THE BELT RAILWAY COMPANY OF CHICAGO

System General Order

#2024-005

Timetable and Rule Book Modifications: (Changes shown Highlighted.)

ITEM 11 – BRC SPEED SIGNALS (TTSI Page 74)

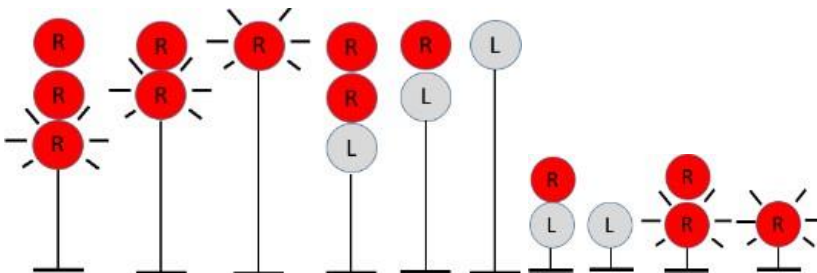
At 67TH STREET, Signals 2R, 4R, 4RA, 2L, 4L, and 4LA are changed from three head mast signals to two head mast signals displaying indications allowing for movement at MEDIUM SPEED in the interlocking.

Where RESTRICTING signals are displayed, these will utilize flashing red aspects in accordance with BRC SSI Rule 9.1.3, RESTRICTING.

9.1.3 RESTRICTING:

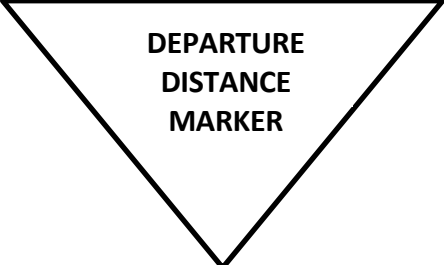
Aspects shown apply when displayed on a signal with, or without, a number plate.
